U. S. ATOMIC ENERGY COMMISSION  
DIRECTORATE OF REGULATORY OPERATIONS

Report of Operations Inspection

RO Inspection Report No. 050-G10/74-13  
RO Inspection Report No. 050-010/74-09

Dresden Nuclear Power Station Units 1 and 2  
Morris, Illinois

# Dresden 2 Recirculation Pipe Defects

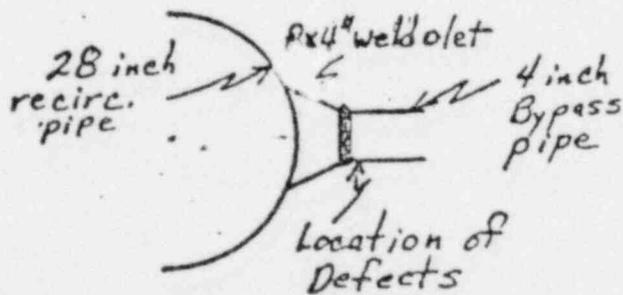
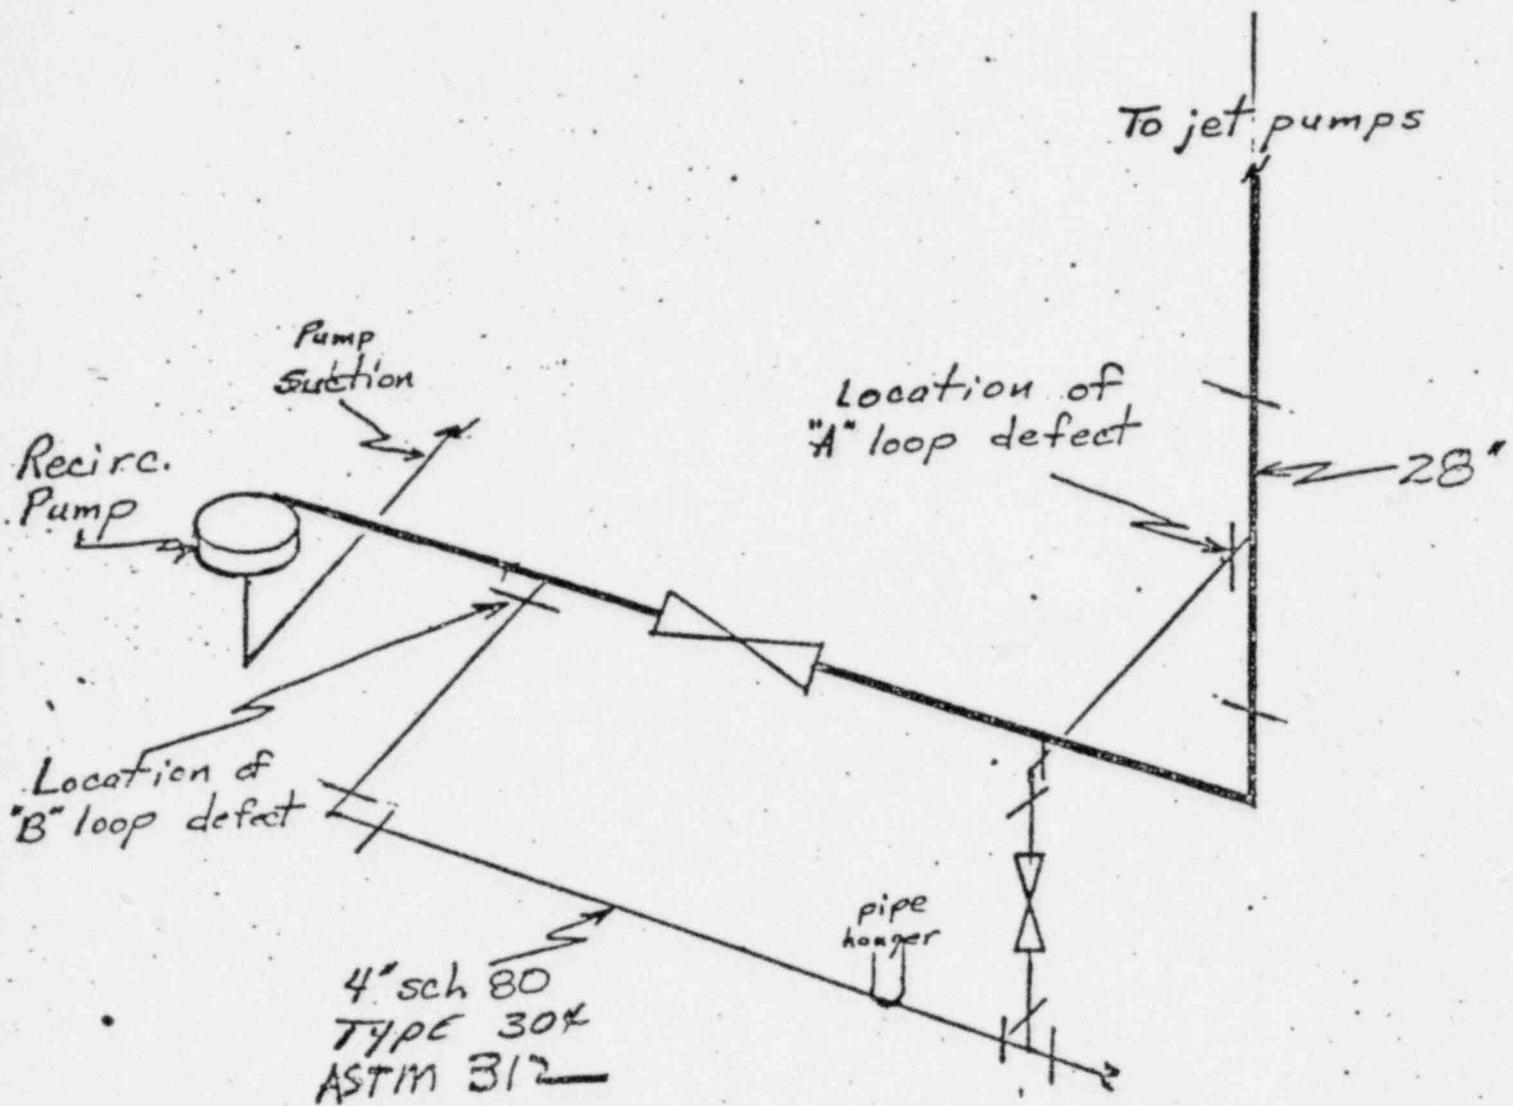
On September 12, 1974, the unit was shutdown as the unidentified primary system leakage within containment was approaching the 5 gpm limit. On September 13, the licensee discovered a circumferential crack in the four-inch stainless steel bypass line around the "B" recirculation pump discharge valve. On September 15, a similar failure was found in the "A" loop. Refer to attachment A for location and size of cracks.

OD and ID cracks  
in 4" pipe
